**RE: Development Application
s100B – Subdivision – Torrens Title Subdivision
6 Wilton Drive and 62 Mount Vincient Road, East Maitland NSW 2323,
8//DP855275, 141//DP1225076, 142//DP1225076**

Please find herewith additional information as requested by RFS and as discussed with you in **BOLD** with the response following:

Attachment 1 – Bushfire Threat Assessment Report

BUSHFIRE THREAT ASSESSMENT

Attachment 2 – Site Plans

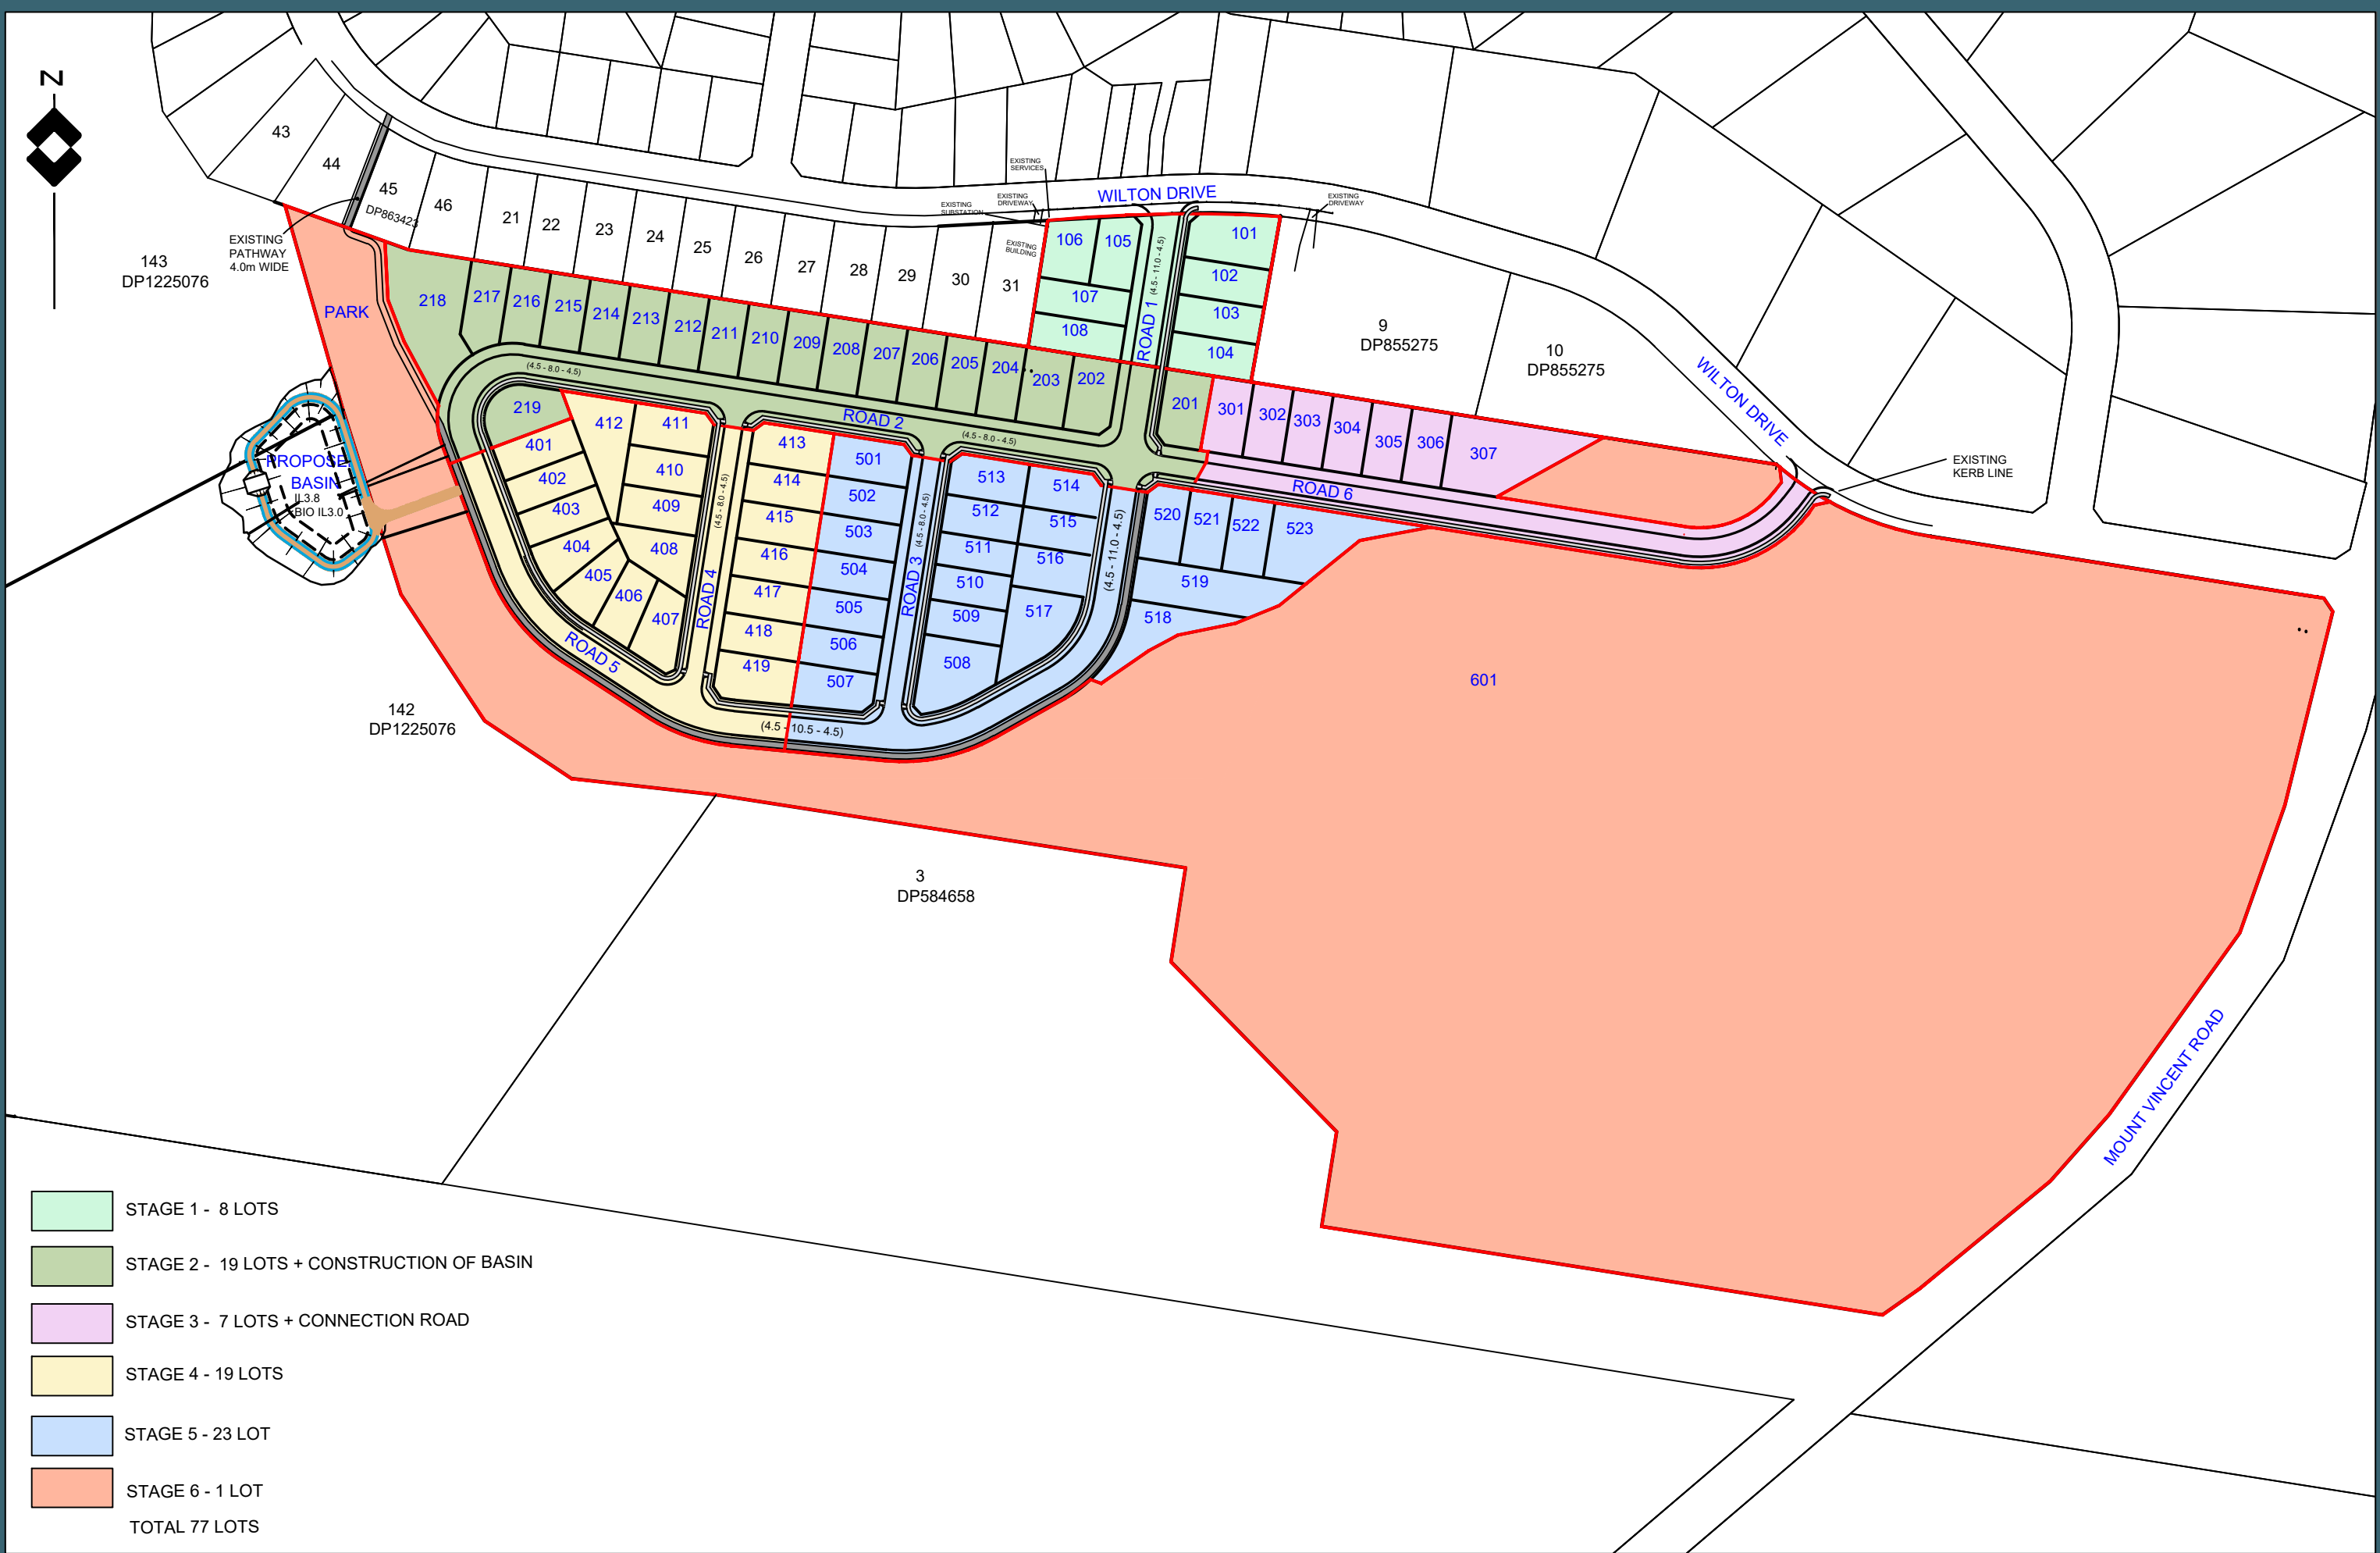
- **Staging is to be revised to provide a secondary access from development of stage 2.**

Refer to Attachment 2 site plans showing the secondary access which is to be provided at the time of Stage 3 construction.

For development within Stage 1 and 2, there will be direct access to Road 1 and Road 2 and a temporary turning head can be provided for efficient access / egress until such time that the secondary access is provided by Road 6. Furthermore, Road 1 will not be cut off by bushfire hazards.
